SERVICE BULLETIN MAINTENANCE OF WAY EQUIPMENT

DATE: 8-8-2002 **BULLETIN NO:** 02-016

TITLE: F026006 PRE-SQUEEZE TIMER RELAY

PRODUCT SERIES / MODEL: RMC306 Series A / B ANCHOR BOXER[®] Anchor Applicators

FIGURE 1
PRE-SQUEEZE TIMER RELAY LOCATION
Control Box - All Models Except B2-27 and Brainerd Rebuilt

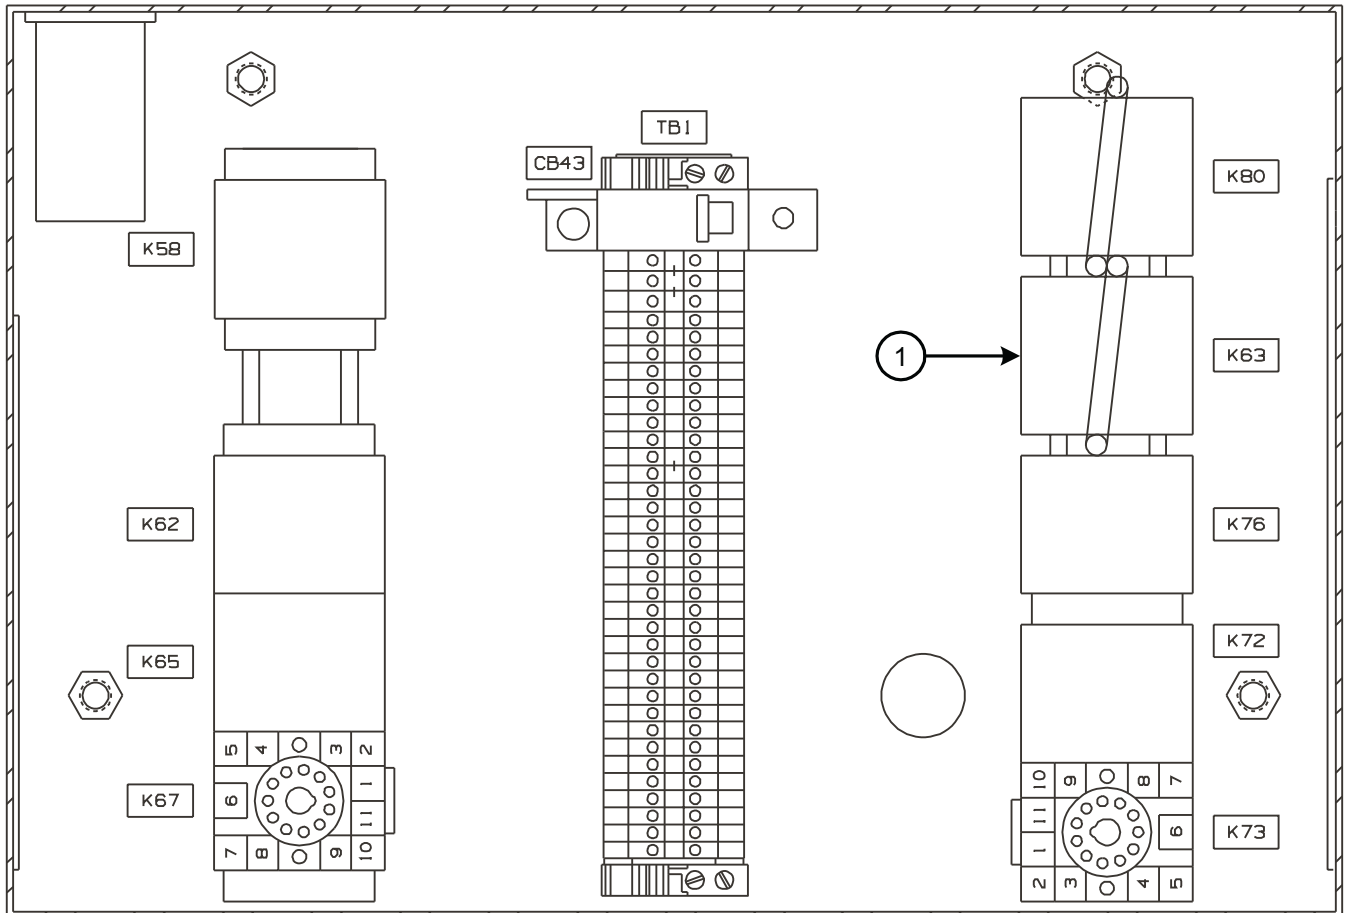
9. All Models Except B2-27 and Brainerd Rebuilt: See Figure 1. Open the panel of the Control Box located on the right side of the machine. Locate the pre-squeeze timer relay K63 (1) inside of the Control Box.

FIGURE 2
PRE-SQUEEZE TIMER RELAY LOCATION
Relay Box - Models B2-27 Only

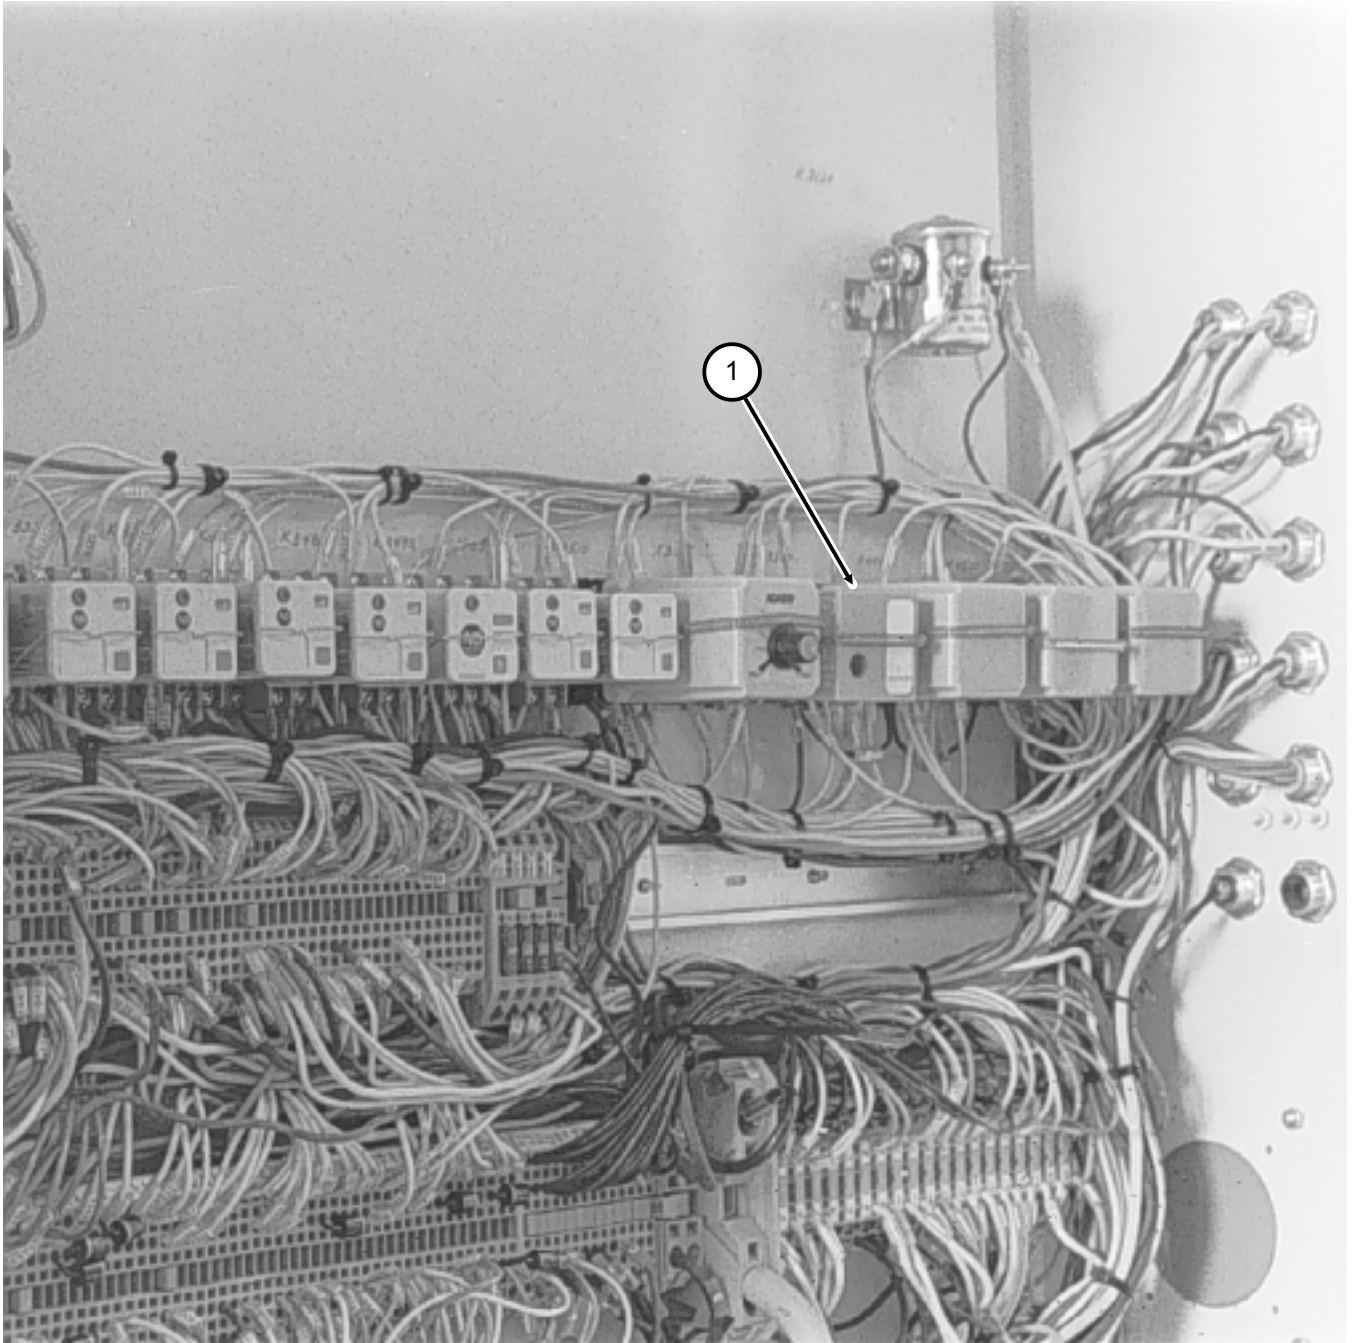
10. Models B2-27 and Brainerd Rebuilt Only: See Figure 2 and Figure 3. Open the cover of the Relay Box located on the rear of the machine next to the fuel tank. Locate the pre-squeeze timer relay K3225 (1) inside of the Relay Box.

FIGURE 4

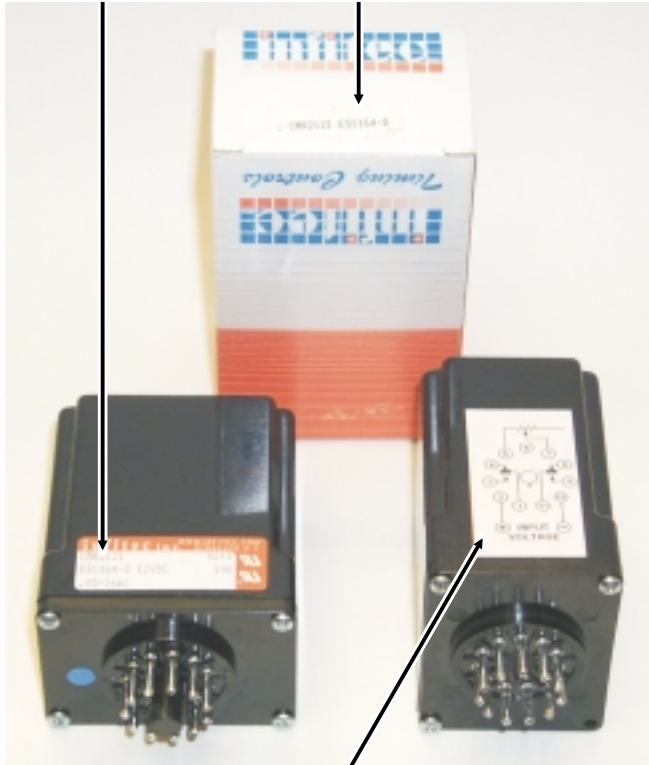
12. Timer Relay Part # F026006 - See Figure 4. This relay is manufactured by Infitec. This relay is black in color, has a wiring schematic on the side cover, and has a label on the front cover with identification # ES1164-D. This is the new timer relay part # F026006 that replaces the original timer relay part # 502663000.

Relay Is Labeled ES1164-D
On The Relay And On The Box

Relay Will Have The Schematic Shown
in Figure 6 On The Side Cover

F026006 RELAY PIN WIRING

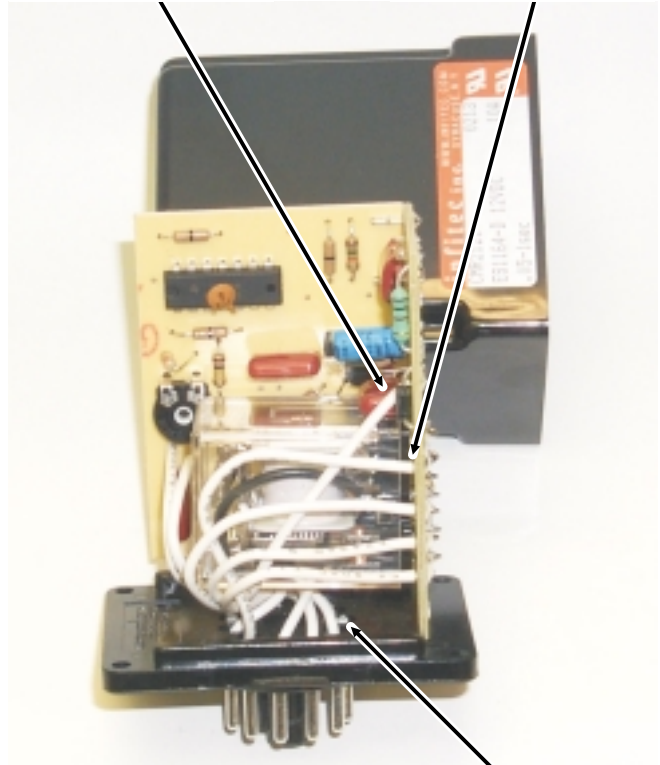
- 12.1 Inspect the timer relay for the proper pin configuration wiring as shown in Figure 5 and Figure 6. The positive (+) wire must be connected to pin #2 and the negative (-) wire must be connected to pin #10. The wire at pin #6 will be cut off.

This Wire (+) Will
Go To Pin #2

This Wire (-) Will
Go To Pin #10

This Wire Will Be
Cut Off At Pin #6

- 12.2 If the timer relay is found to have the wrong pin configuration wiring, contact the vendor from where the relay was purchased to obtain a new timer relay with the proper pin configuration wiring.
